Re: 21 Nethermont Ave - Section, Block & Lot: 122.16/4/41

Below are responses to the questions/comments from Kellard Sessions received 09/21/2020:

Response to RPRC Review Comments

SW-1
 SHEET 1 of 2

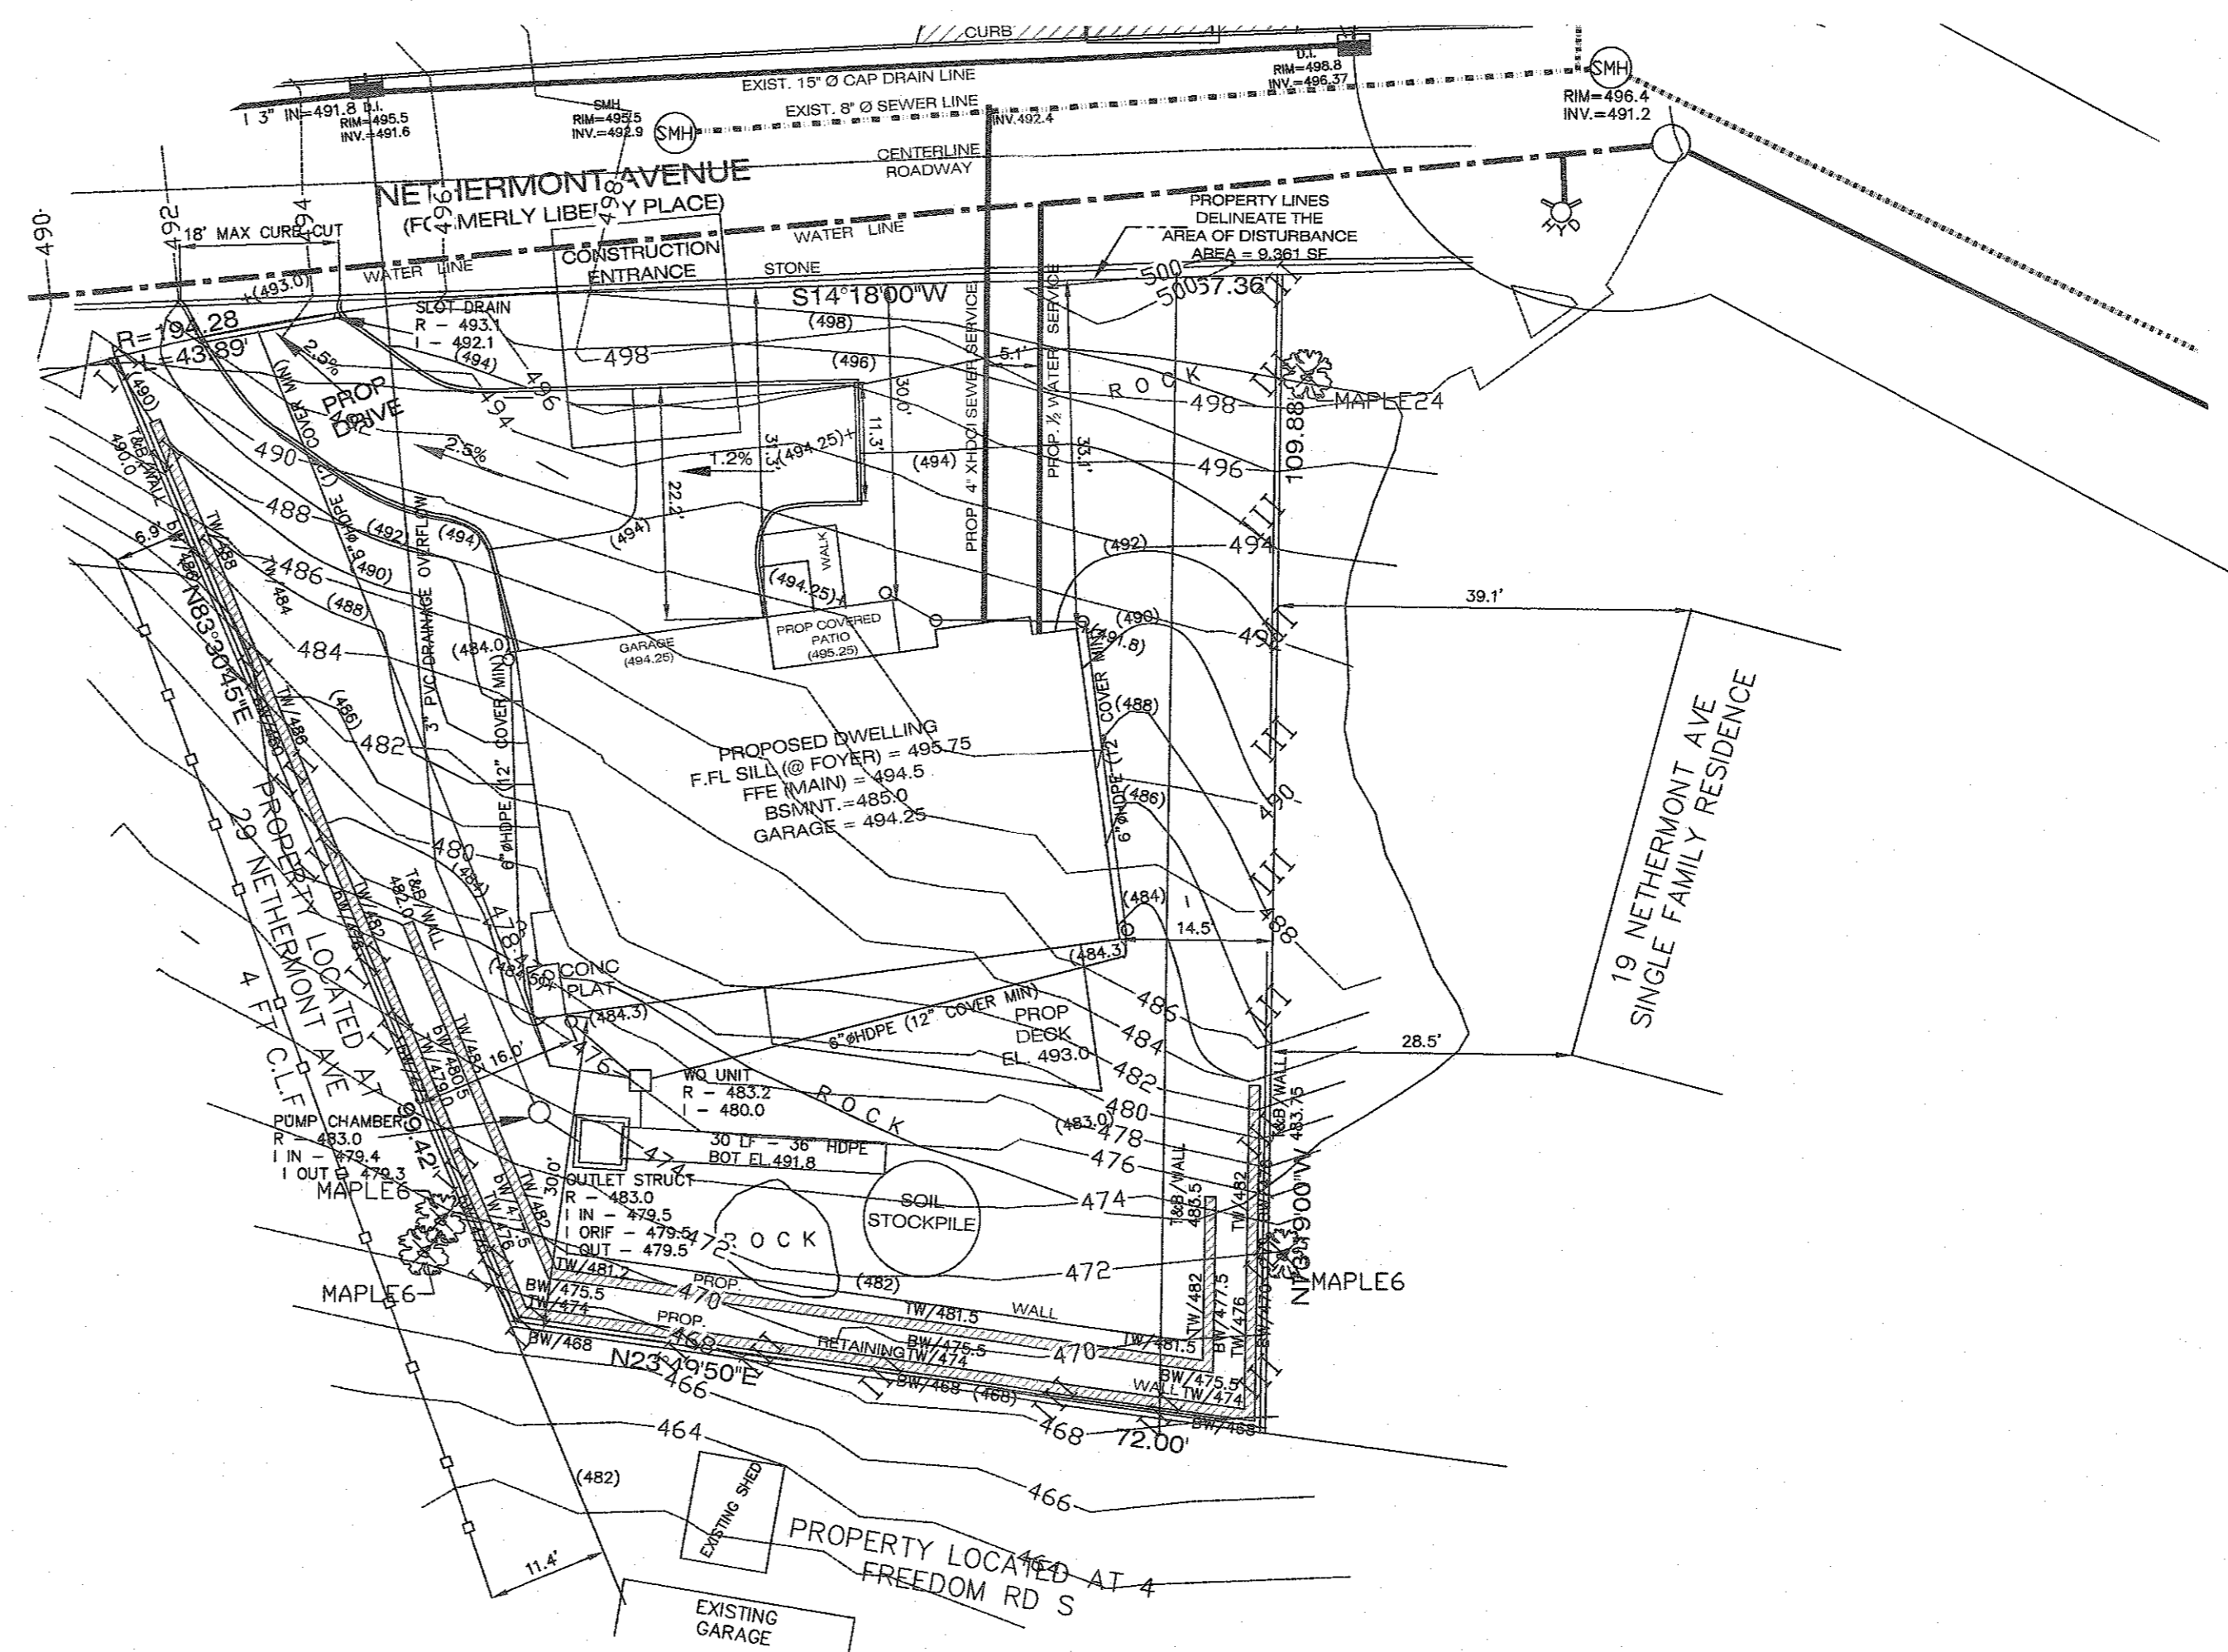
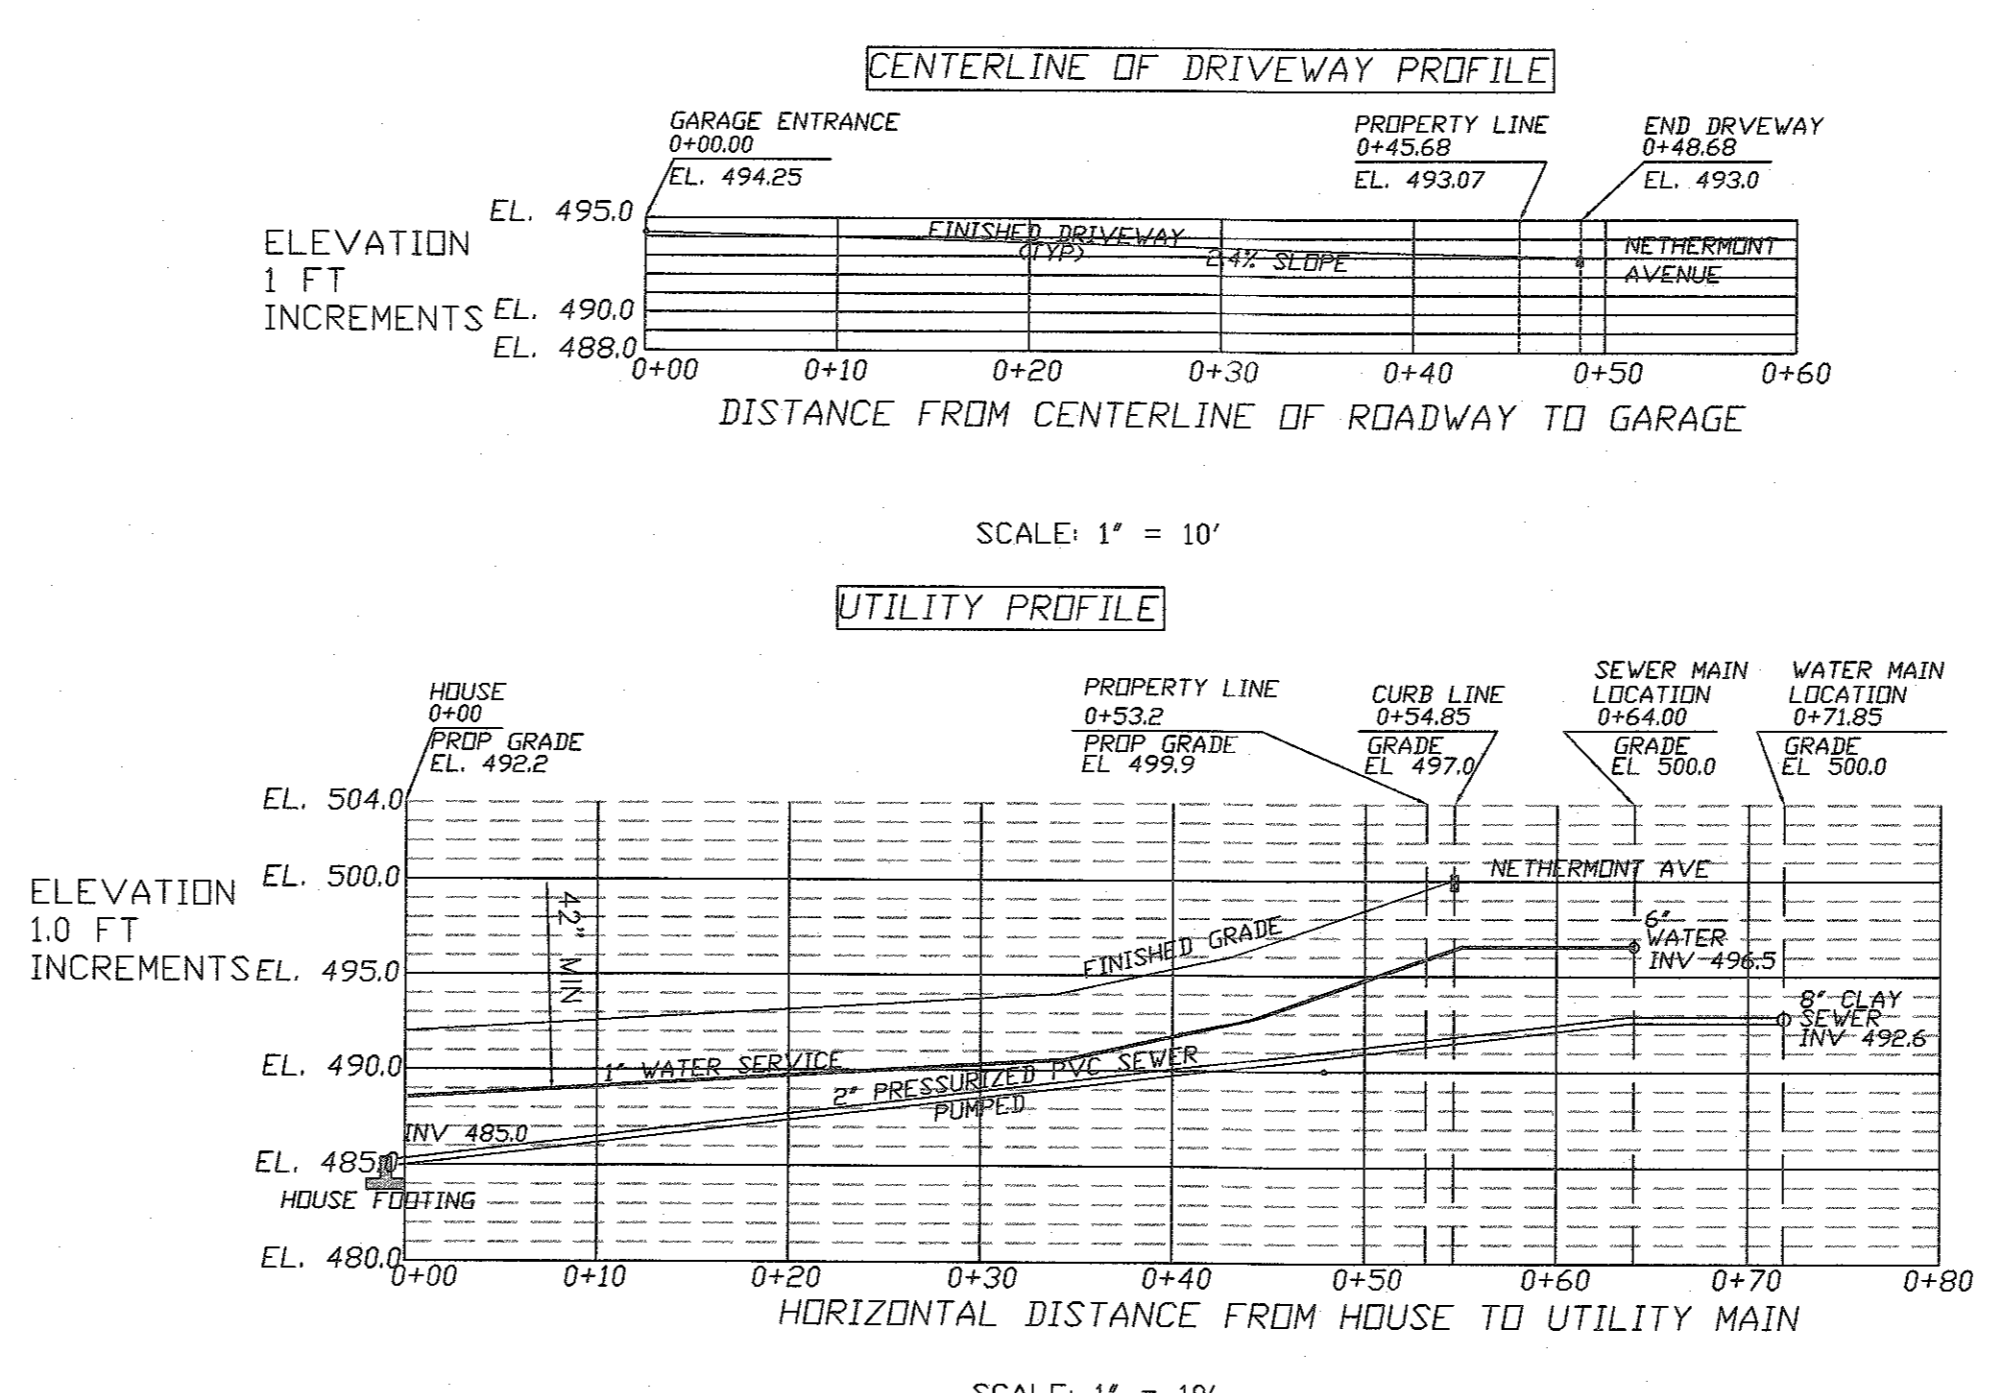
- It appears that a significant portion of the site is rock. Cut and fill estimates shall be prepared to estimate the quantity of fill that is required for the project and the amount of rock that will be removed.

- It appears the drawing scale for the plan on Sheet SW-1 is incorrect. The scale shall be revised, as necessary.
 - Scale has been corrected.
- The plan shall illustrate and note that all proposed driveway curb cuts shall be a maximum of 18 feet wide. Revise the plan and detail, as necessary.

- The drainage calculation table on Sheet SW-1 shall be revised for post-development conditions to illustrate the 100-year storm.
 - Post Development has been revised

- The plan shall illustrate and quantify the limit of disturbance. The plan shall not that the limit of disturbance shall be staked in the field prior to construction.

- **We have estimated the quantity of cut and fill for the project. The quantities are noted on sheet 1 of 2, SW-1, under the average grade calcs.**

- The property lines delineate the area of disturbance. A note with an arrow has been added to the plan to clarify that. In addition, the note you requested has been added.

21 NETHERMONT SIGHT DISTANCE PLAN VIEW

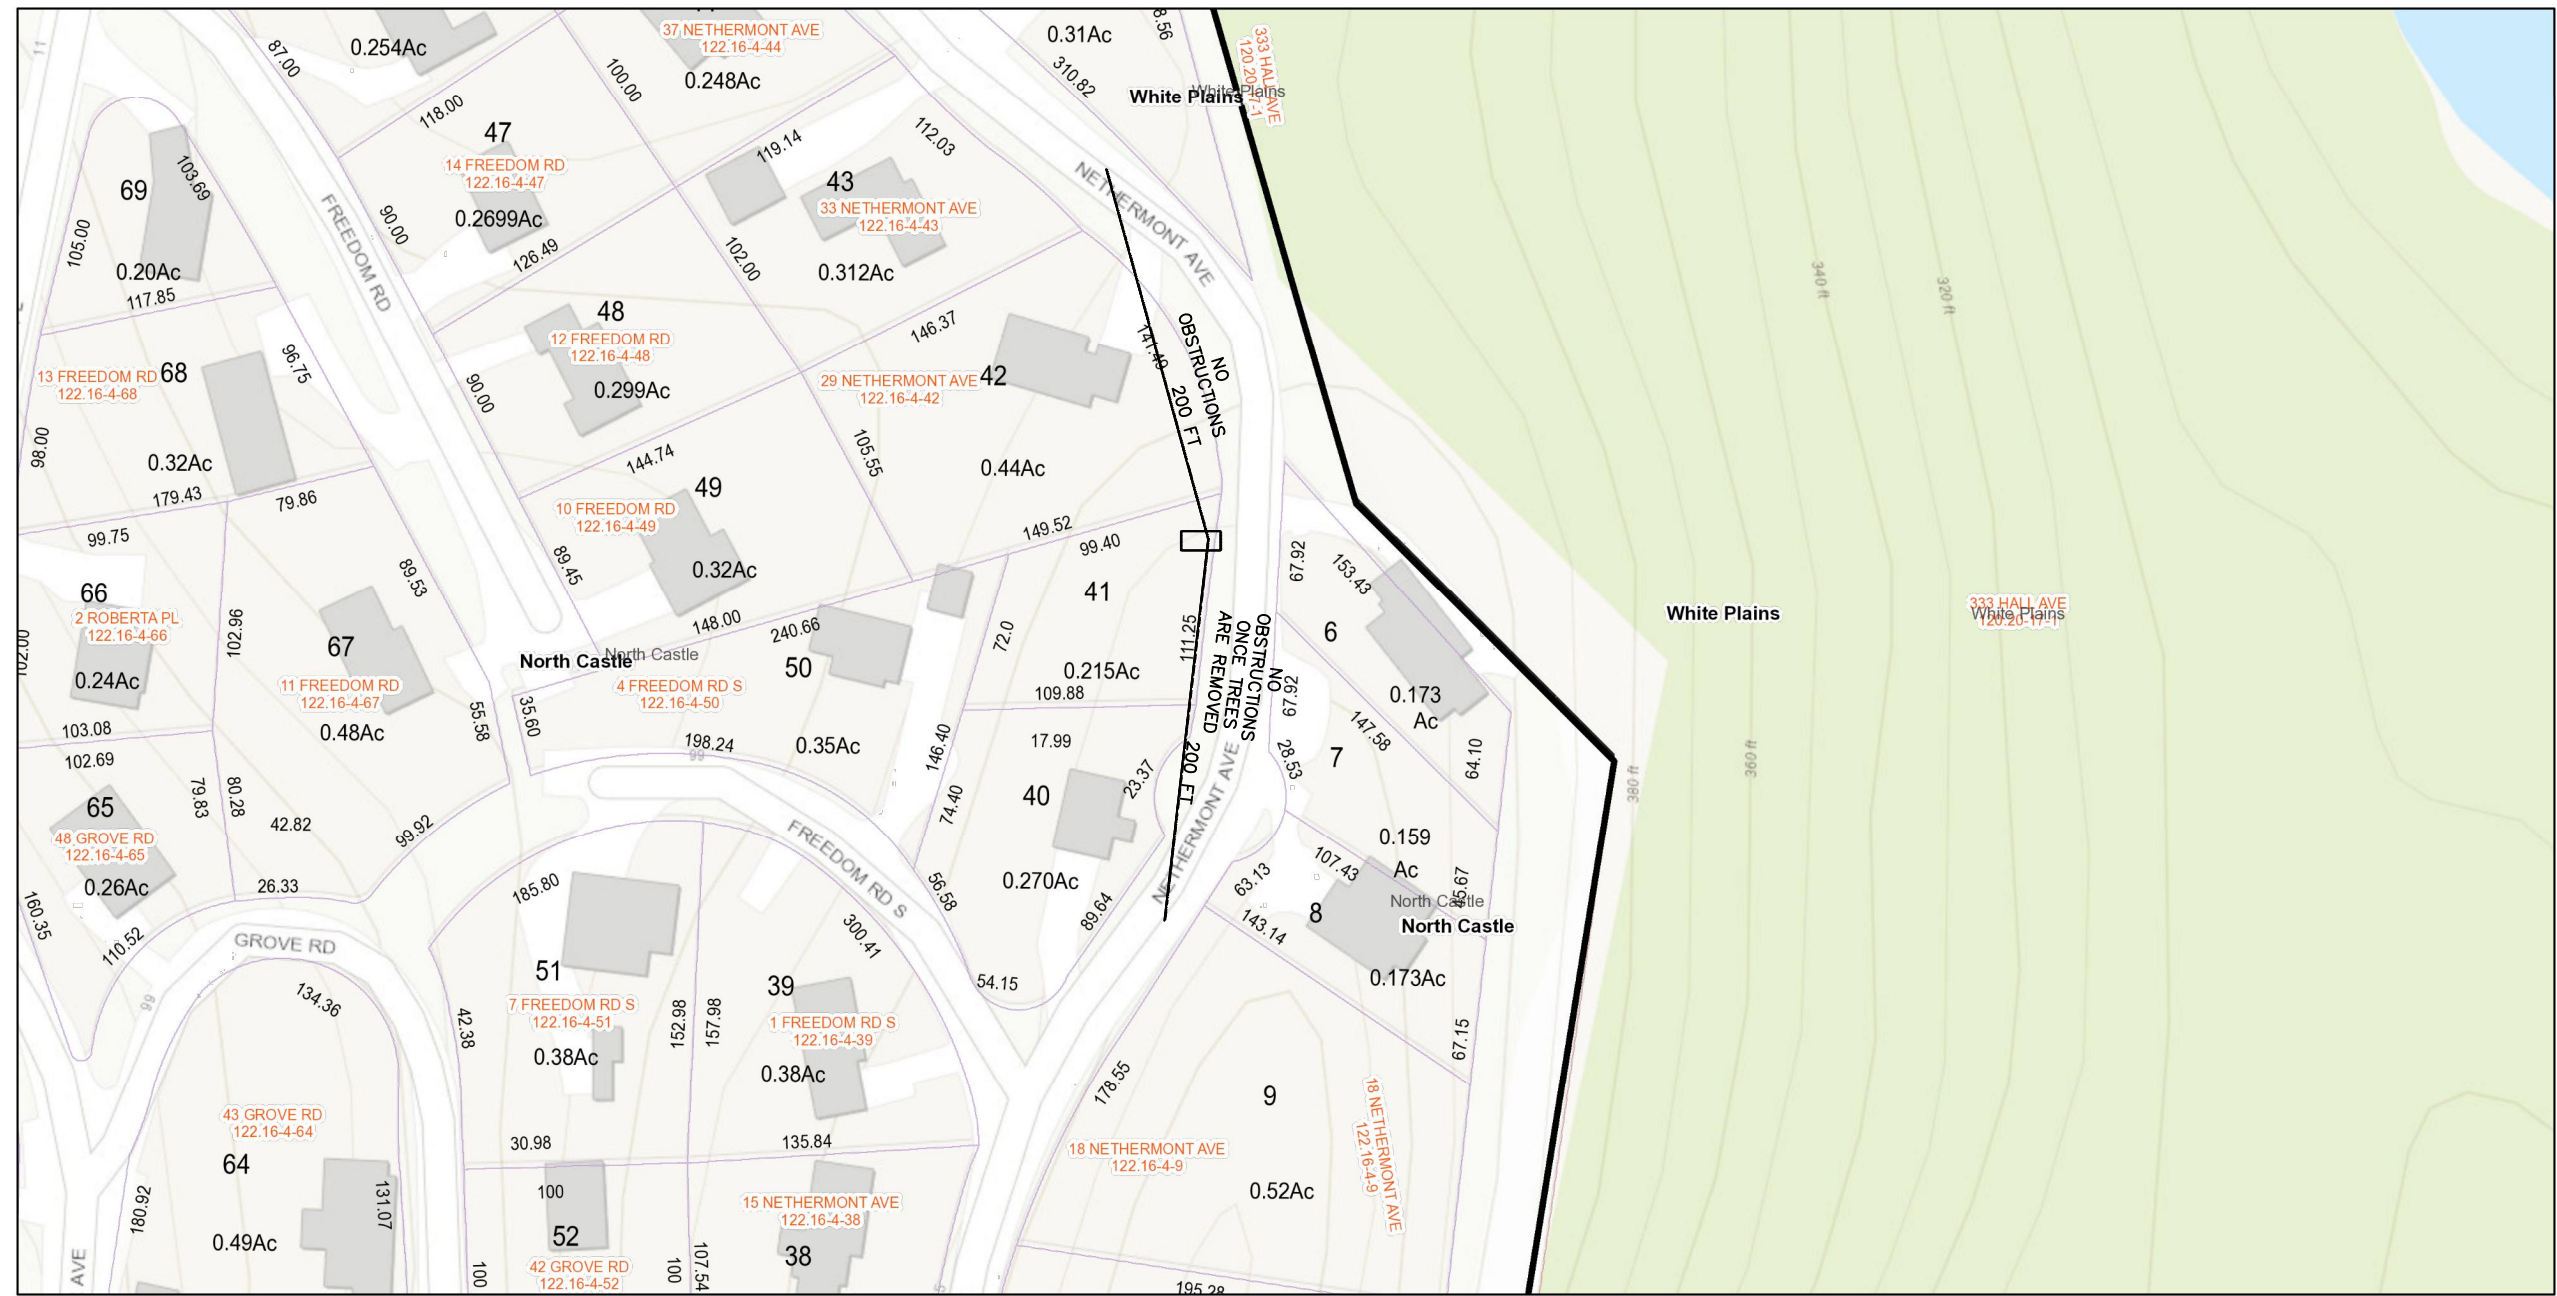
- Sight distance profiles have been provided. However, a sight line plan shall also be provided correctly illustrating adequate sight distance 200 feet in each direction. In addition, the sight line profile shall be adjusted to reflect the driver's eye at 3.5 ft above finished grade, 14.5 ft back from the edge of the traveled way, to an object in the road 2 ft above finished grade.

- **Sight Distance Analysis updated.**
- Due to the geometry of Nethermont Avenue, we recommend that the applicant consider an alternative driveway alignment with access from the eastern side of the proposed house.
